OREGON PARKS & RECREATION DEPARTMENT  
5330 Seaman Road  
Oregon, Ohio 43616  
(419) 698-7145  
FAX (419) 698-7086

**ADDENDUM No. 1**  
**Recreation Buildings - 2023**

Plan holders of the Recreation Buildings - 2023 Project are hereby notified of the following amendments to the Contract Documents. The following additions, alterations, deletions and/or clarifications shall be part of the bid specifications as much as if they were originally included in the Contract Documents. This Addendum No. 1 is hereby made a part of the Contract Documents and must be receipted for on the proposal form.

A7.2

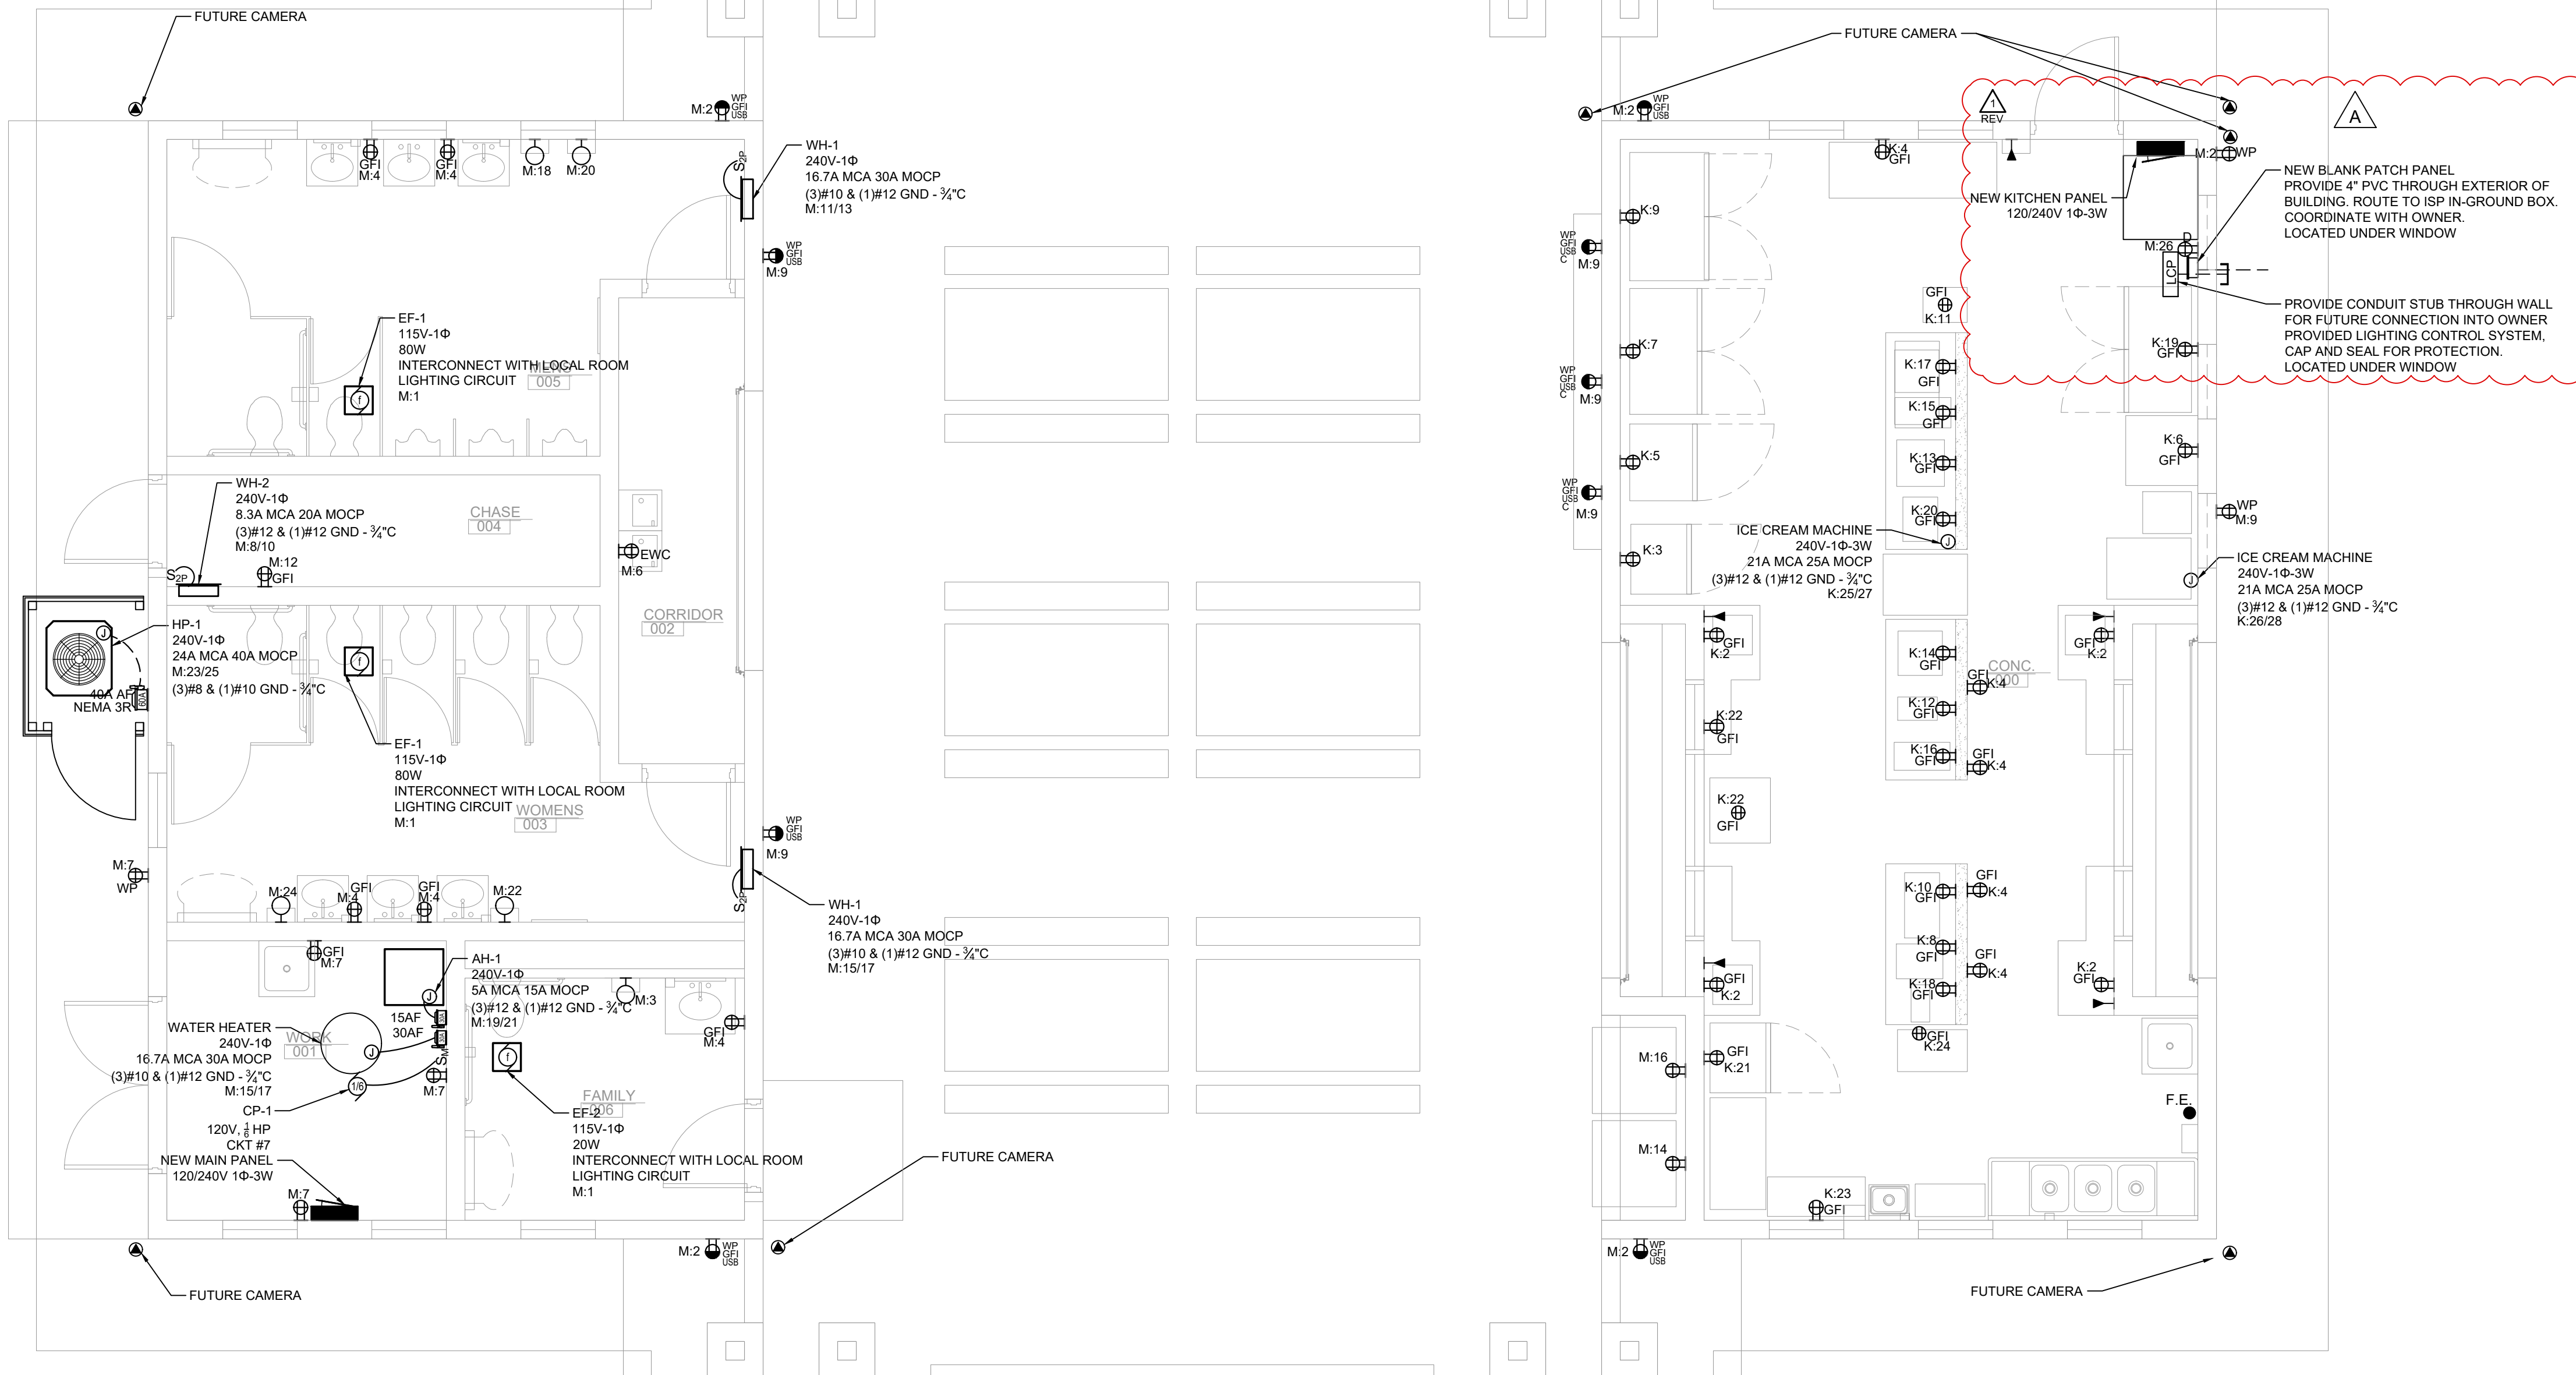
- 10) **Bidder Question:** *If the fixtures are to be changed to surface mount. This will ultimately add a lot of access holes for all the trades. Is there a specific access cover that is required?*

**Architect/Engineer Response:** The lights will be surface mounted. Access will be in the attic. Provide attic access doors as shown on the attached revised drawings A7.1 and A7.2. The access door can be found in specification section 09 21 16. Note the section was changed in this addendum, see note above.
